Contract #: 04-0120F4Cty: SF/ALA Rte: 80 PM: 13.2/13.9File #: 69.25B**QUALITY ASSURANCE -- NON-CONFORMANCE REPORT****Location:** Shanghai, China**Report No:** NCR-000025**Prime Contractor:** American Bridge/Fluor Enterprises, a JV**Date:** 25-Dec-2007**Submitting Contractor:** Zhenhua Port Machinery Company, Ltd (ZPMC), Changxing Island**NCR #:** ZPMC-0024**Type of problem:**

Job Name: SAS Superstructure

Subject: NCR No. ZPMC-0024

项目名称 Project Name	美国海湾大桥 SFOBB	部件图号 Drawing No	SP30	报告编号 Report No.	B-WR021
合同号 Contract No.:	04-0120F4	部件名称 Items Name	底板装配图-5型 底板Bottom asse mble-5 type plate	NDT报告编号 Report No.of NDT	
项目编号 Project No.:	ZP06-787

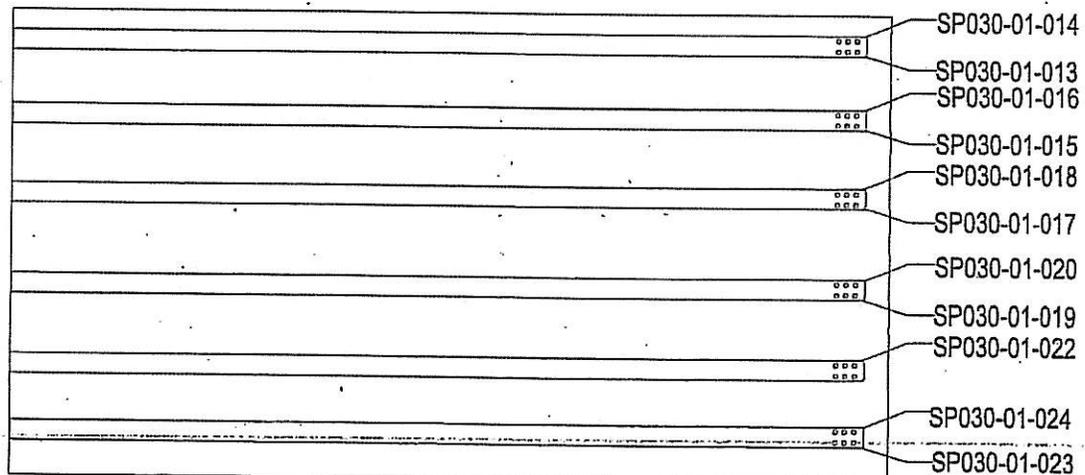
3B-C5东线箱梁底板SP30在完工报验时发现11处整条焊角不足。图纸要求8mm焊角，现实际测量7mm-6.5mm。具体见详图:

There are not the enough size in 11 welds of 3B-C5 east box bottom plate(SP30),The requirement of the drawings is 8mm,but it is only 7mm in maximum 6mm in minimum. The following drawings show the detail.

Not enough welding process and excessive grinding.

1. The weld will be grinded flush and cleared.
2. Welding will be performed according to the relevant WPS (WPS-B-T-2132-1).
3. Grinding the weld according to the requirement of approved shop drawing.
4. Perform NDT of the weld according to the shop drawing..
5. Preheat prior to welding to a minimum temperature of 10°C
